PF225 Change Request

47

O-1, O-2, O-3

PF225 Change Request

First Approach

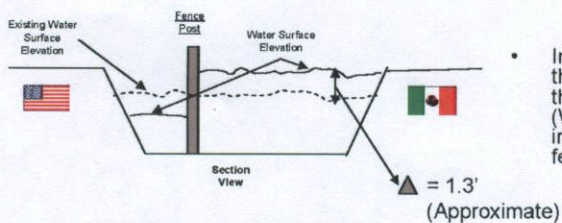
- Current analysis assumes a reasonable but relatively high lateral flow rate. This resulted in relatively low change in (WSE) and minimum impact on Mexican side of fence.

Second Approach

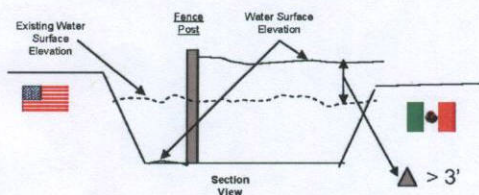
- Independent check recommended changing the lateral flow modeling approach to reduce the lateral flow rates which will increase the (WSE) on south side of the fence and further increase the impacts on Mexican side of fence.
